RE: 3rd & Virginia Project - 2000 3rd Ave
Subject: Permit #3026416-LU – Master Use Permit Comments

SUBJECT: Response to City's Correction Notice #1 (TRANSPORT)
3rd & Virginia; City of Seattle MUP #3026416
TENW Project No. 5378

This document provides responses to the City's Correction Notice #1 (TRANSPORT) dated October 3, 2019 (see **Attachment A**) based on review of our TIA dated May 13, 2019. The City's Correction Notice included seven comments; responses to each of the comments are provided below.

LOADING AREA PLAN - LEVEL P1M

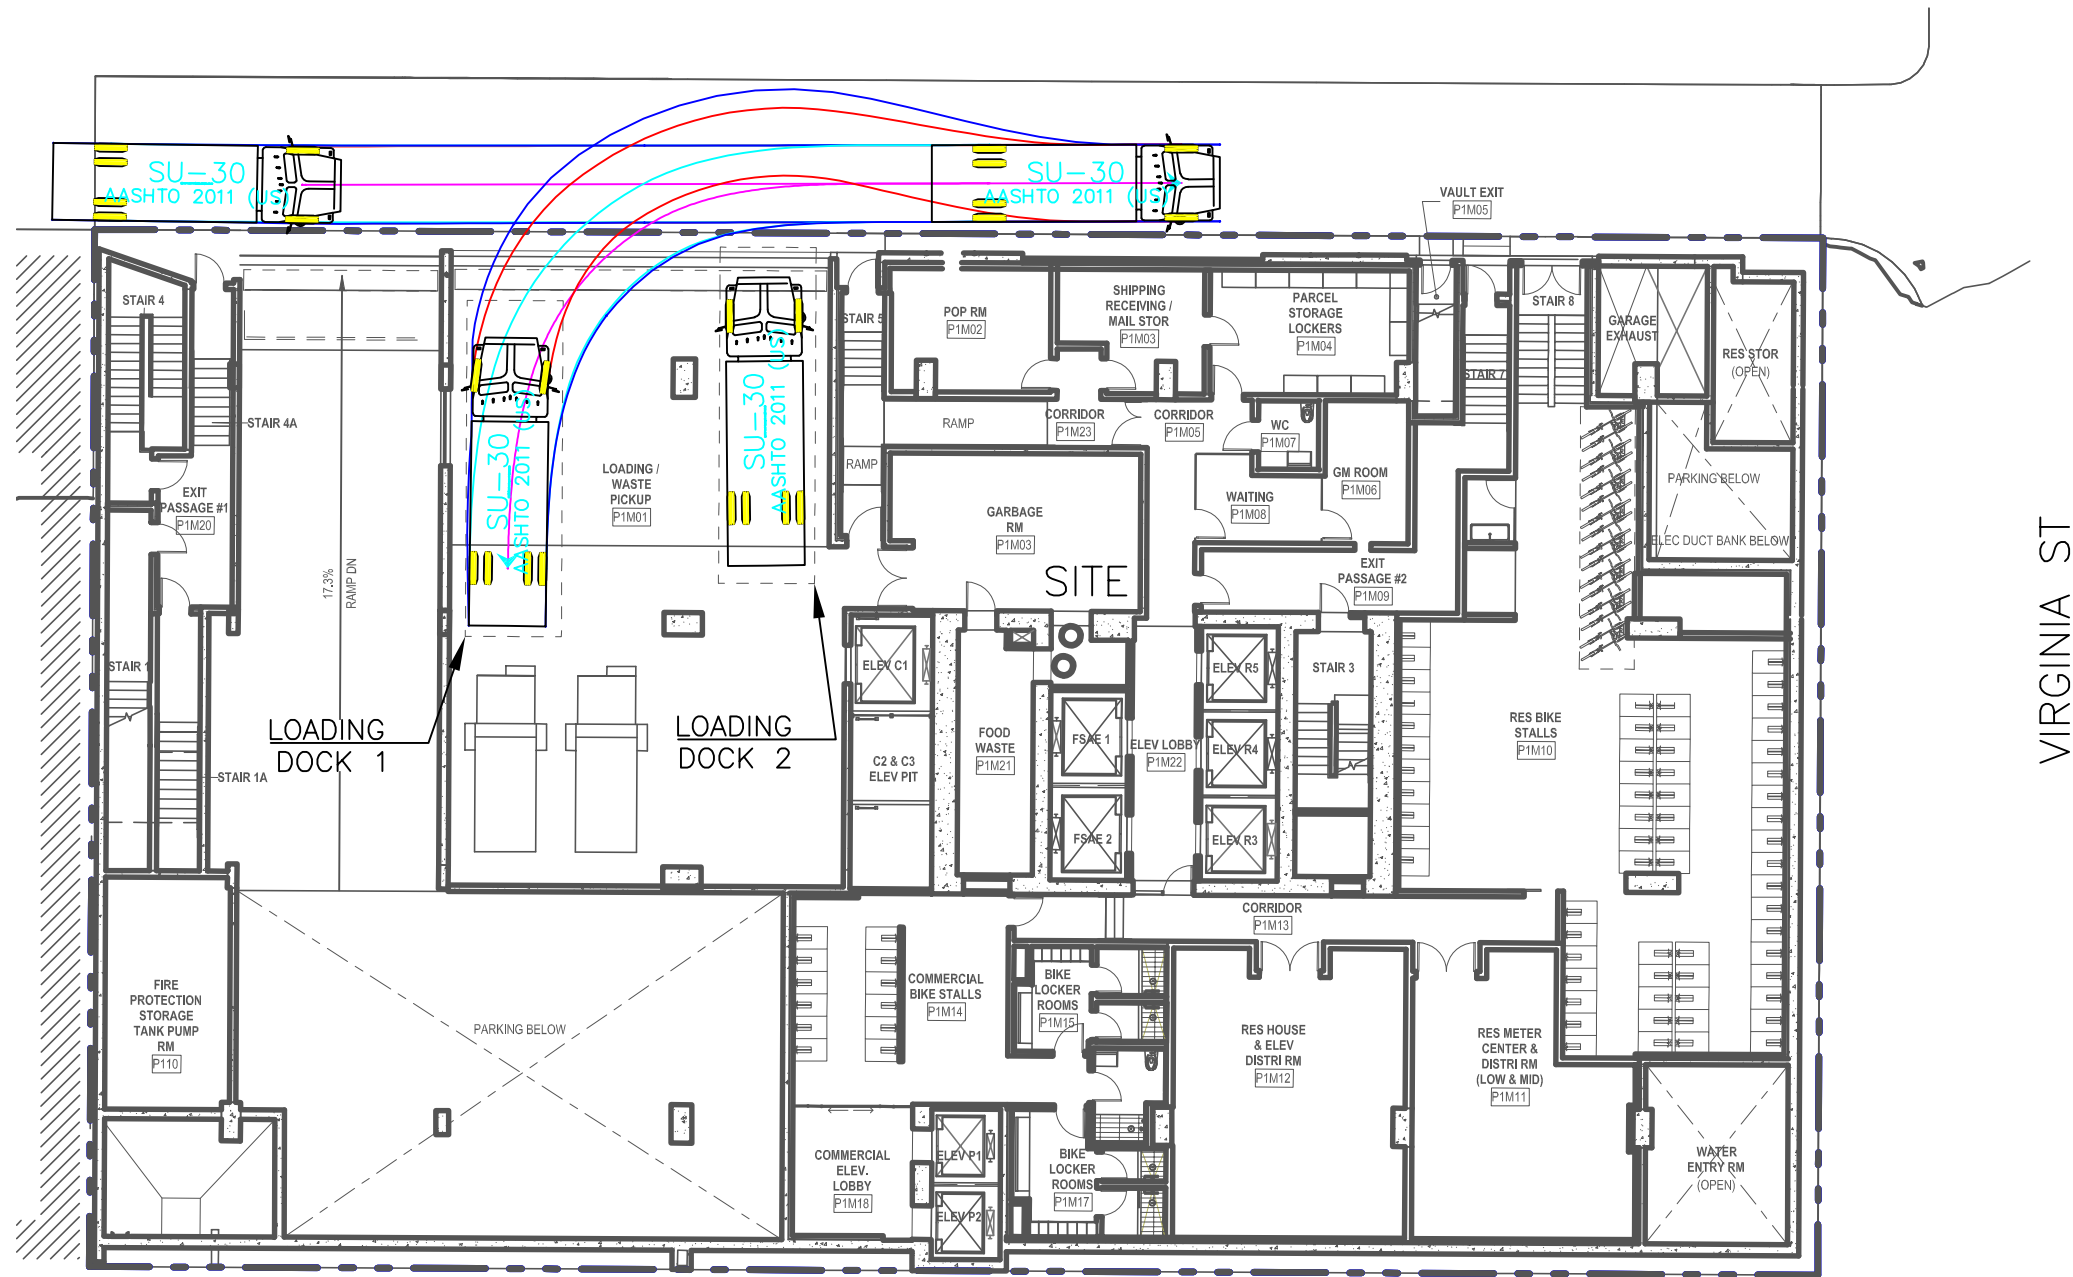
Comment #6 Appendix D: Please provide a more detailed diagram showing the dimension of the clear area behind the trucks and the positioning of the trucks within the berth, to demonstrate that trucks would not extend into the alley when ramps or lift gates are deployed.

Please see loading dock plan with dimensions of the loading berths and area behind for lift gates and ramps included as **Attachment B**. It should be noted that the dark line shown at the end of the ramp portion is not a dock, just a transition in the floor slab. The elevated dock portion has been removed since the initial MUP submittal to accommodate the truck length.

AUTOTURN ANALYSIS
LOADING DOCK 1 – ENTERING

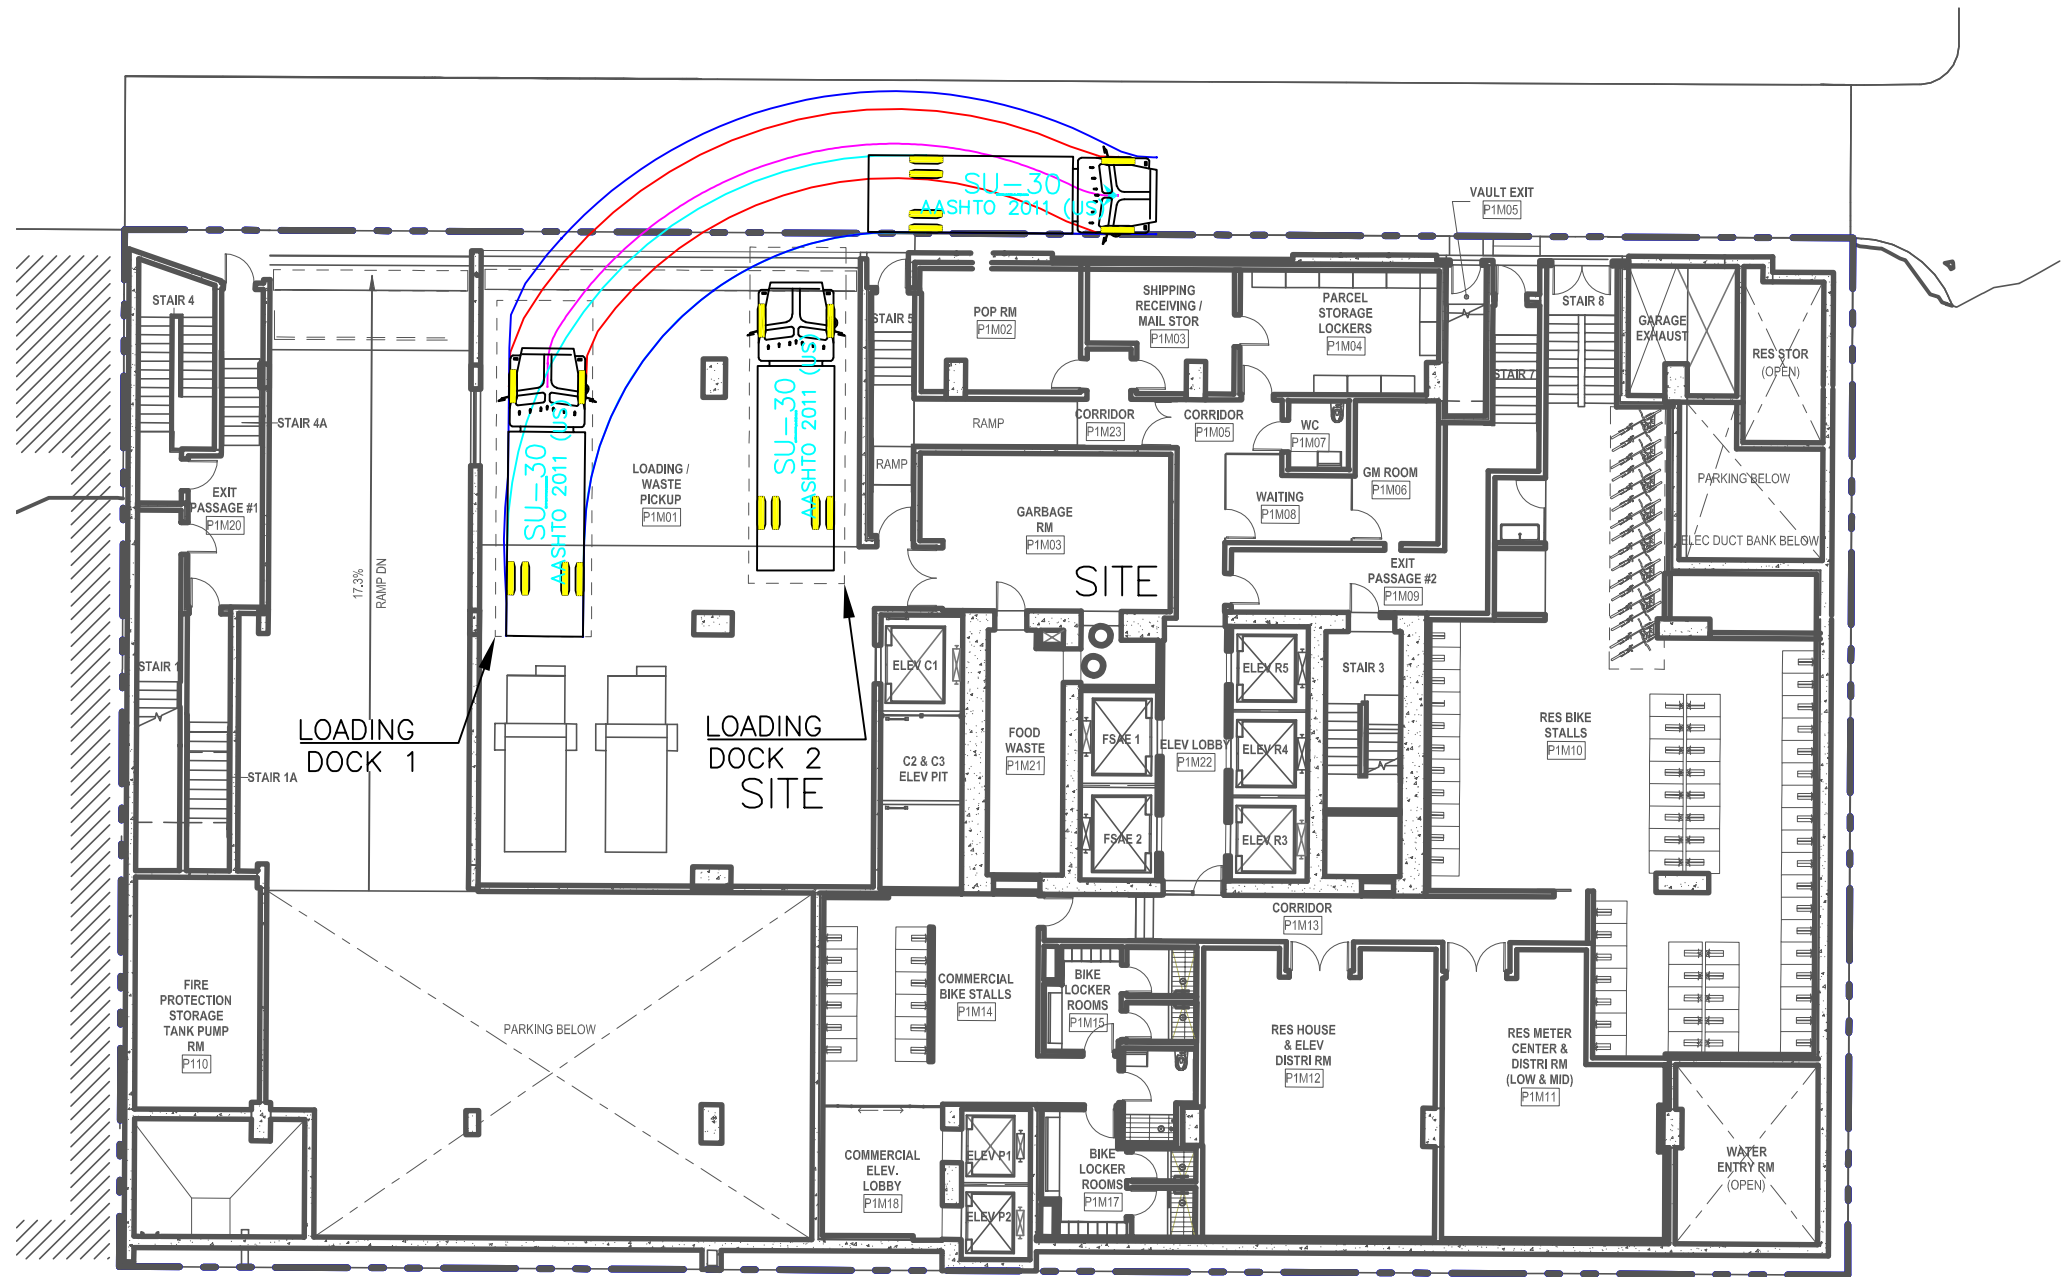
Comment #7 Appendix D: On all of the turning movement diagrams, particularly sheets 1 and 3, the envelope of the design vehicle is shown very close to the outline of the existing building on the north side of the alley. To allow for sufficient distance for truck mirrors, please provide turning movements that accommodate 1' clearance from the design vehicle to the existing building façade.

See revised AutoTURN analysis included as **Attachment C**.
